ADDENDUM NUMBER 1

GREENFIELD PARK  
GOLF COURSE IRRIGATION PUMP STATION  
Site # 766694  
12035 West Greenfield Avenue  
West Allis, WI

Project Number: P287-13648

Date of Addendum: May 8, 2014

PUMP STATION CONNECTION DETAIL

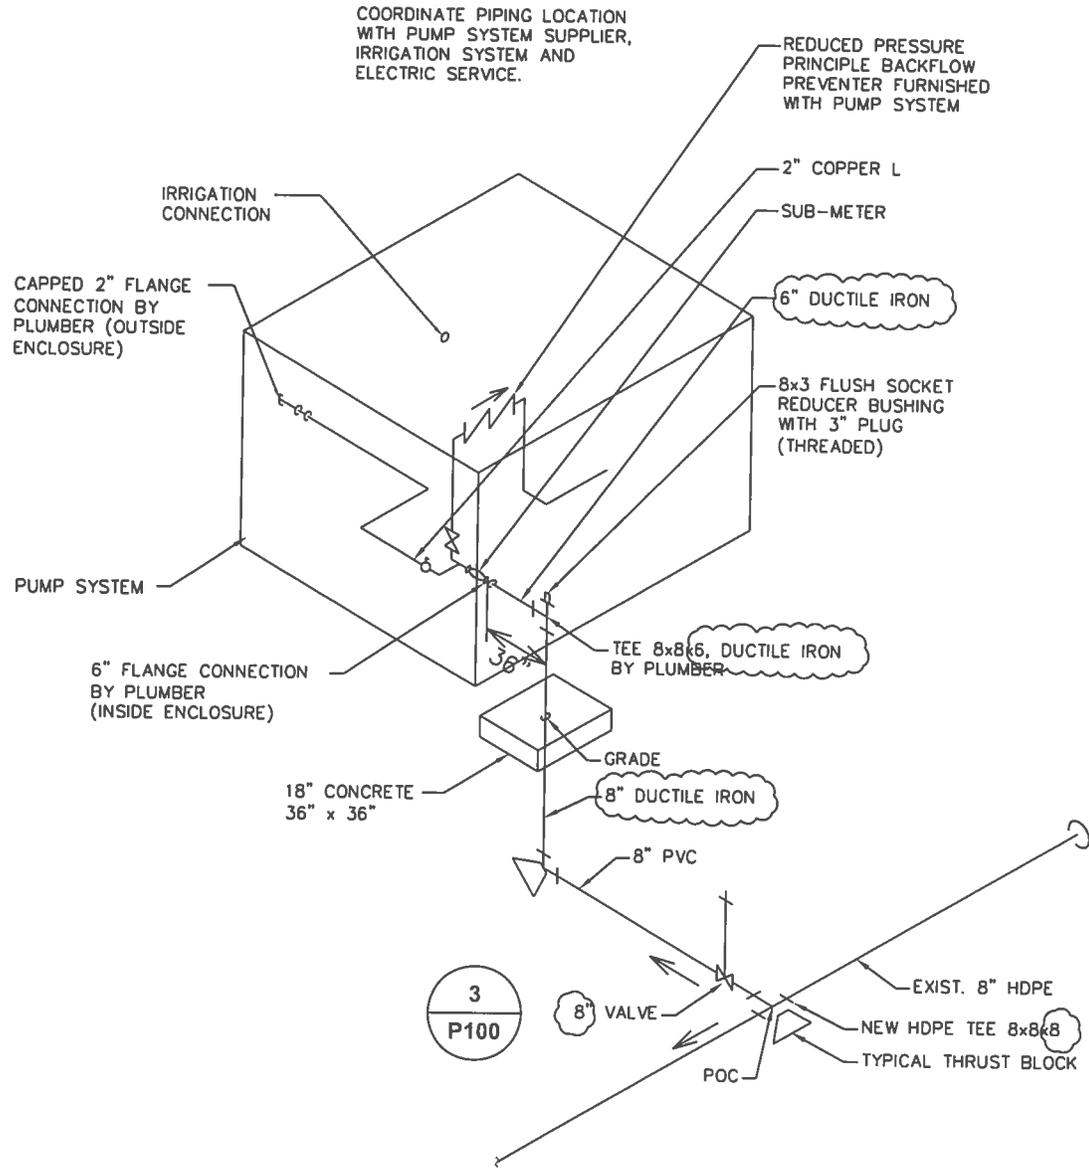
Attached is a revised pump station connection detail. Changes are as follows:

- Change main water shut off valve from 6-inch to 8-inch.
- Change 8-inch riser pipe from PVC to ductile iron.
- Change riser pipe tee to ductile iron
- Change 6-inch pipe to pump station to ductile iron
